## P11 – 12

### Proposed Change as Submitted

**Proponent:** Shawn Strausbaugh representing the ICC PMG Code Action Committee

**Figure 1 Run-time of Water Heater (or Boiler) with Two Different Pump Controls**

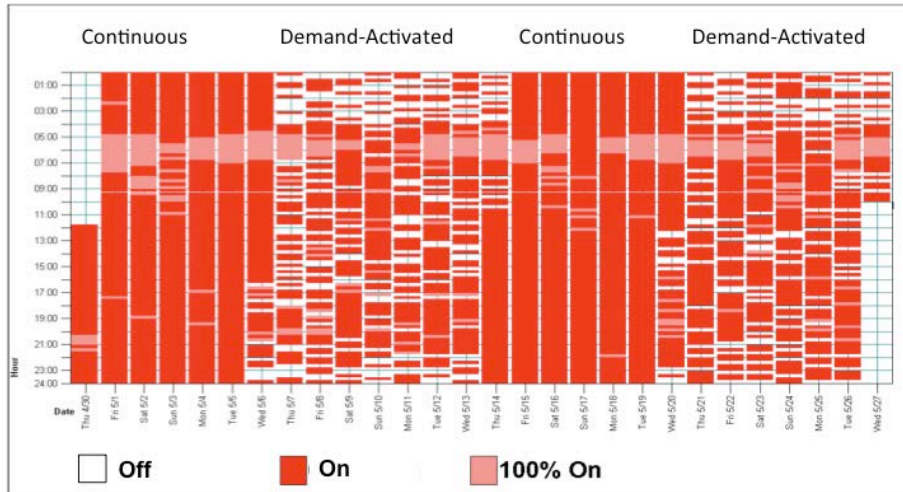
Figure 1 shows the differences in run-time at the water heater (or boiler) between a continuously pumped recirculation loop and one that has a demand activated recirculation pump control. The test results come from studies done by Southern California Gas Company on multi-family buildings with central water heaters and recirculation systems. Most systems tested were built before

insulation was required on hot water recirculation loops. White means the water heater or boiler was off. Red means some percent of run-time between zero and continuous. Pink means the water heater or boiler was running continuously.

A recirculation pump with a combined timer and water-temperature activated recirculation pump control will have run-times between these two extremes.

## Fill Valve After AVB

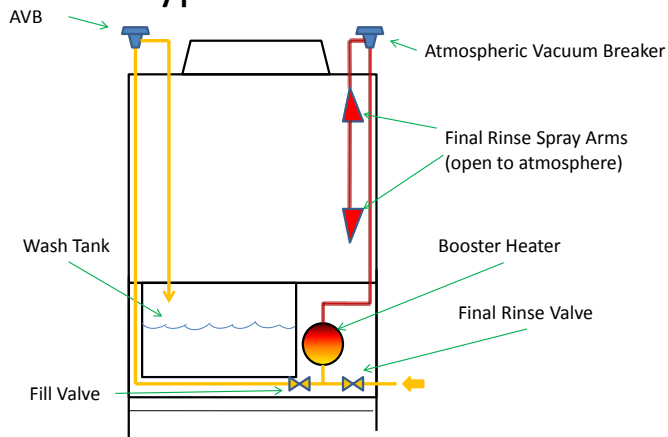
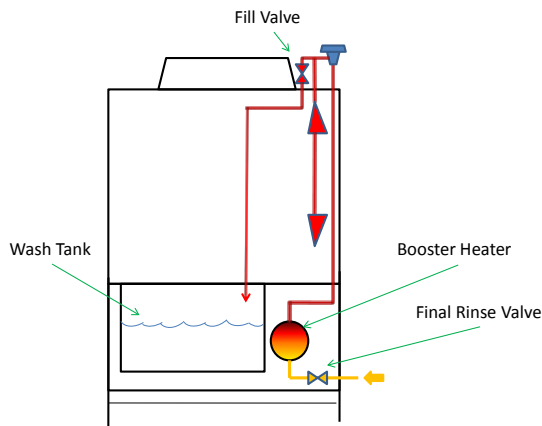
**Commenter's Reason:** The committee action for this issue was "DISAPPROVED" with the committee reason that "the change violates the standard as it would rely on a human to leave a valve open." When this issue was presented at the public hearing, there were no questions from the committee regarding the operation of the valve that could be located downstream from the AVB. However, after the public testimony, a committee member made the statement that he did not approve of the change because it "depended upon an operator to ensure a manual valve was open". This statement is not accurate and there was no opportunity for the presenter to explain the fact that the proposed wording requires the AVB to be open to atmosphere regardless of the position of the downstream valve.
